TYPE O AND ON CARRIER TELEPHONE SYSTEMS—TERMINALS AND JUNCTIONS MODIFICATION PROCEDURE FOR O-H AND ON-H OPERATION

◆ This section is reissued to provide surge (lightning) protection for HIN devices of the OA-H terminal and the ON1-H Junctions. Arrows are used to indicate changes. This reissue does not affect the Equipment Test List.◆

Fig. 2—ON1-H Junctor Group 1, Socket Identification and Equivalent HIN Device Codes

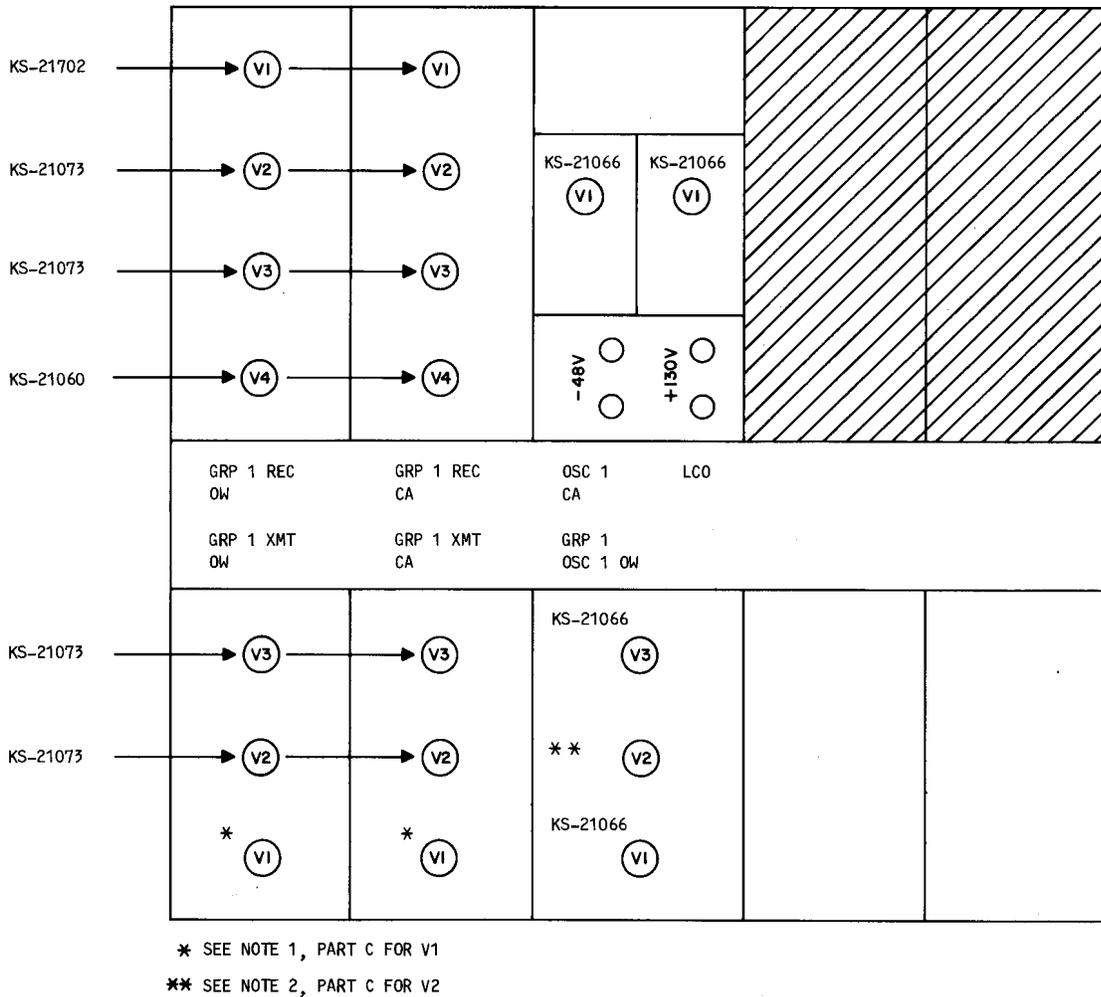
3 When the junction group being modified is equipped with a level control oscillator, remove the 408A electron tube and insert the KS-21066 HIN in the V1 socket per Fig. 2.

5 ♦Install one 521B diode, surge protection device between terminals 1 and 13 of jack J2 of the ON1-H group receive unit (J98705AA, L40, and L41, SD-95174-01, Option DJ), for protection of HIN devices.

Note: The mounting direction of the 521B diode is not critical, as it is a bipolar device.♦
